ADDENDUM

JLG 24146-5 Dunn County Courthouse Renovation

Issued: November 4, 2025

ADDENDUM #: 01

1
M404
ROOF PLAN - AREA B - BASE BID
1/8" = 1'-0"

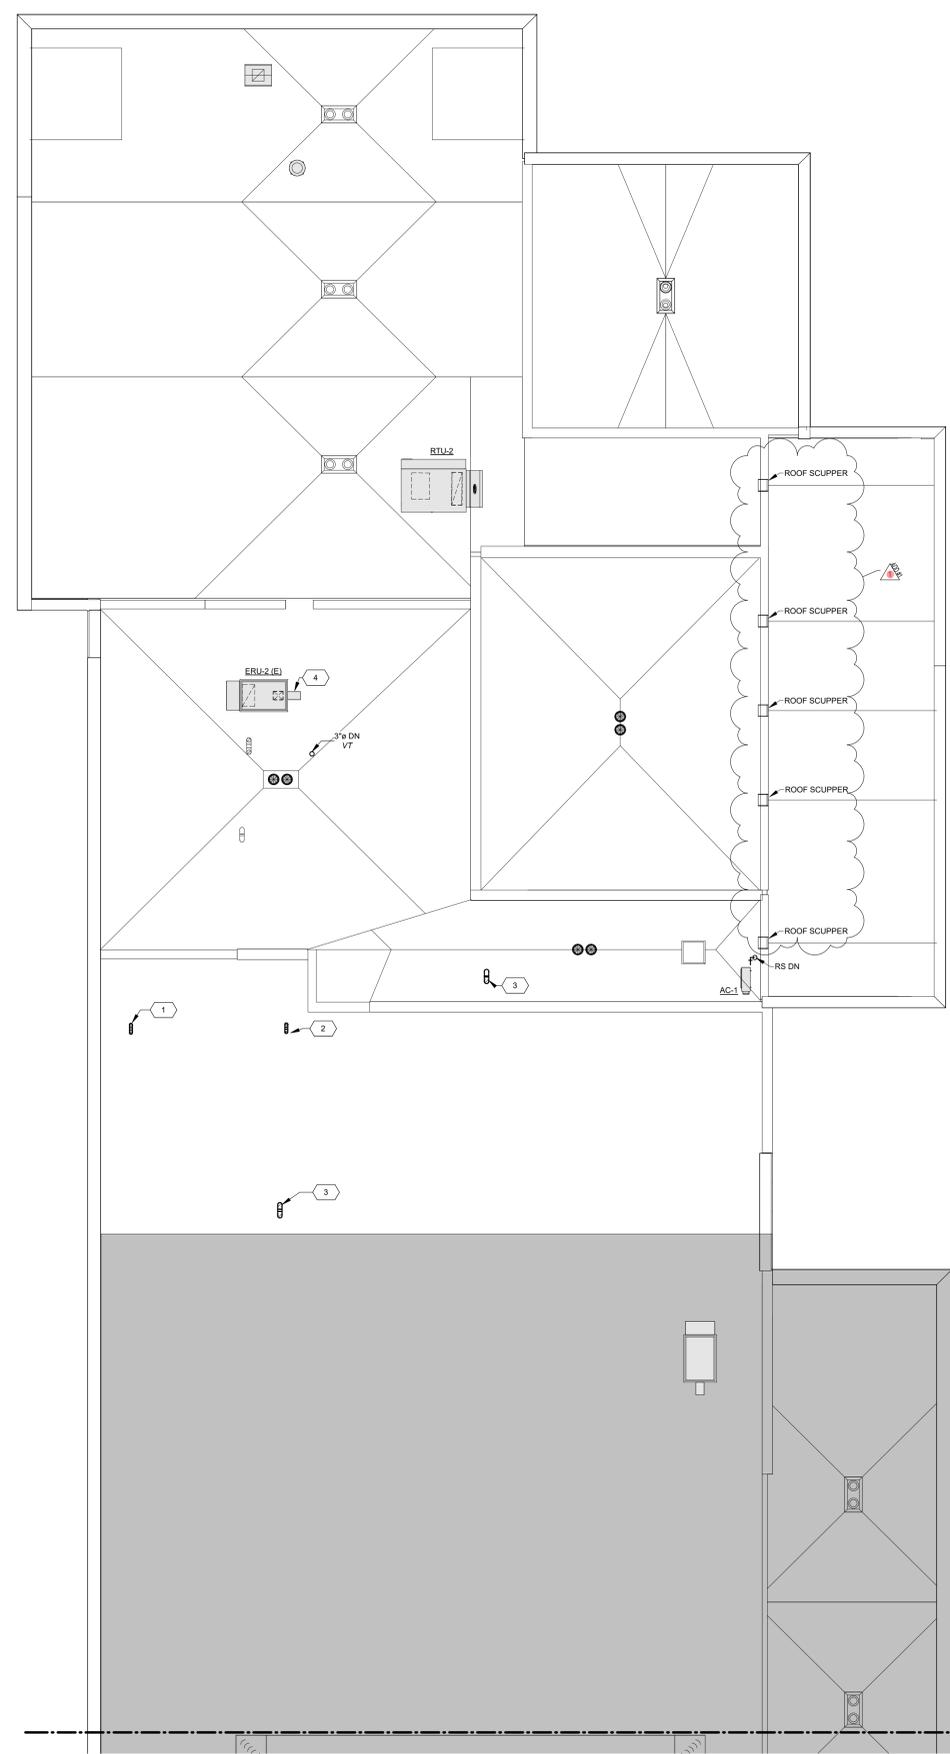
10. M404 – ROOF PLAN
 - Drawing 1/M404:
 - Omit RS-1 scuppers.
11. M502 – DETAILS
 - Detail 6/M502:
 - Single pump in lieu of duplex.
 - Detail 15/M502:
 - Omit detail for Water Outlet Box – Ice Maker.

16 M502 NTS
TYPICAL SOUND BOOT

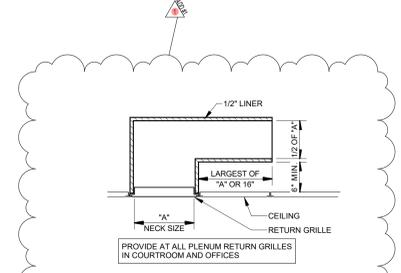
- Detail 16/M502:
 - Provide sound boot on all plenum return grilles in office and courtroom.
